**RE: Water Licence 2AM-MRY1325 September 2019 Inspection**

**Attachment 1:  
2AM-MRY1325 September 2019 Inspection Report**

**Table 1 – Baffinland Responses to CIRNAC Water Licence Inspection – September 2019**

Date	Camera	Inspector	Authorization
	Sony Cyber-shot	J.Mesher	2AM-MRY
Photo Log		Location Iqaluit	
Photo 5

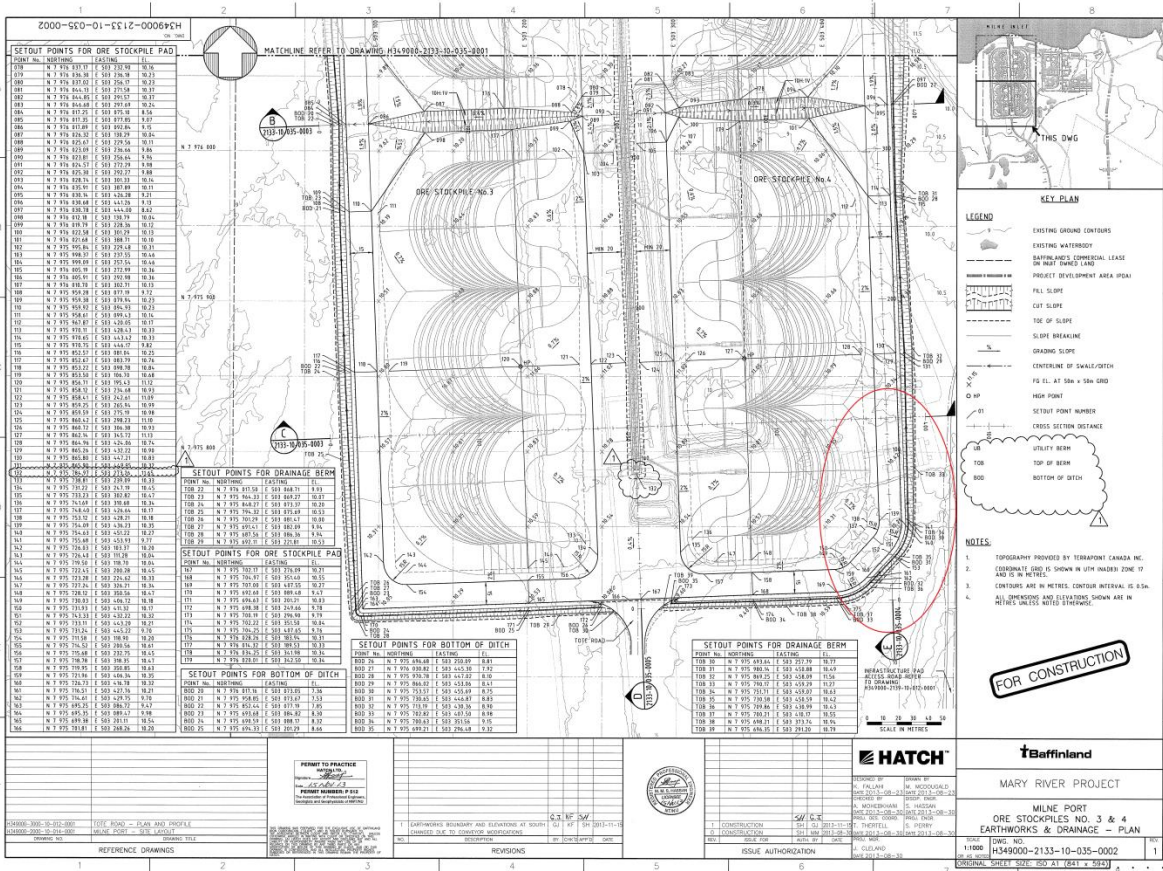
a) During the inspection there was ore blocking the flow path of water in a ditch on the North West side of the Ore Stockpile Pad. The licensee is to remove this Ore. See photo 5

Photo 6

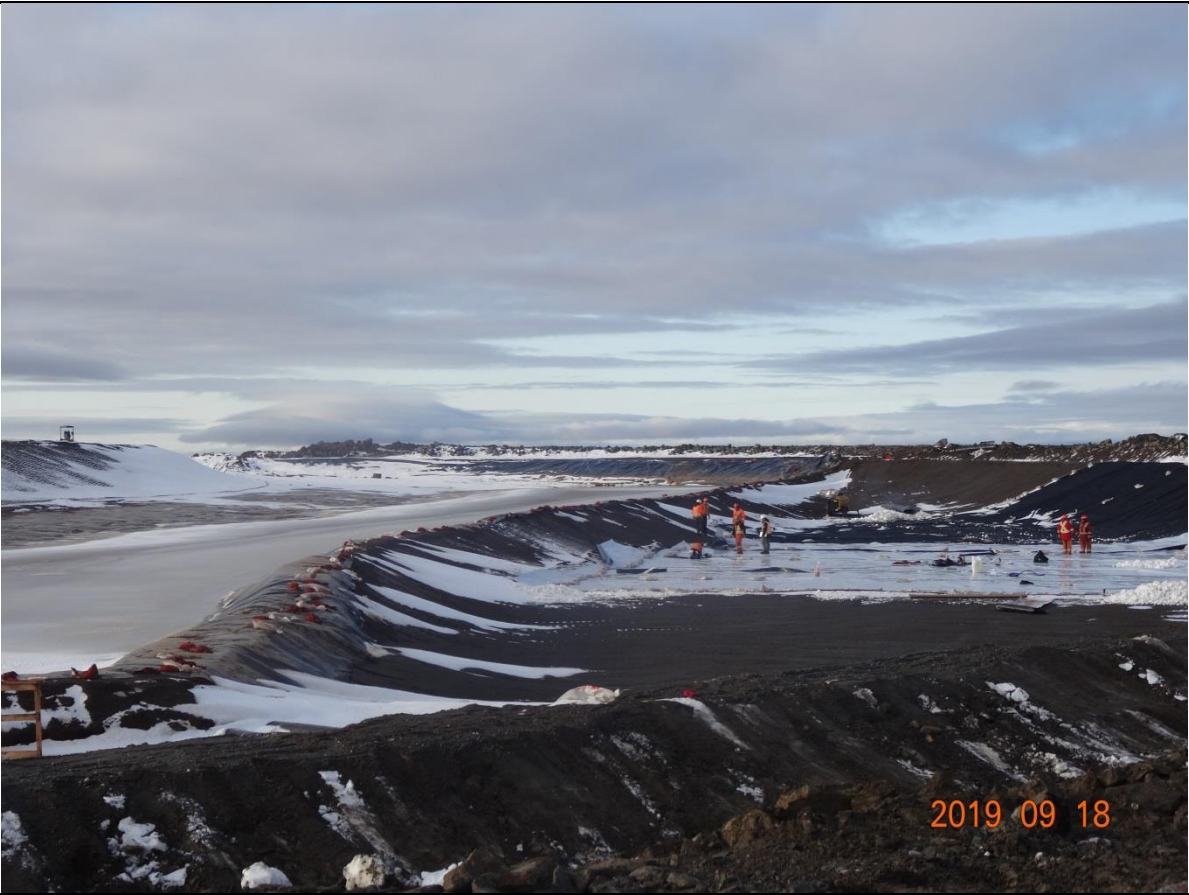
c) The Inspector identified discrepancies between the Ore Stockpile Pad and the provided AS-BUILT/ Issue for construction drawings (IFC) produced by HATCH (H349000-2133-10-035-0002). The Pad appears to be missing outer berms and the ditches on the SE side near the entrance. Once identified, the inspector requested the licensee to install the required ditches within 30 days as of September 17, 2019 and is to install all berms described in the engineered drawings. The missing ditches and berms are approximately within the red circle on Photo 6.
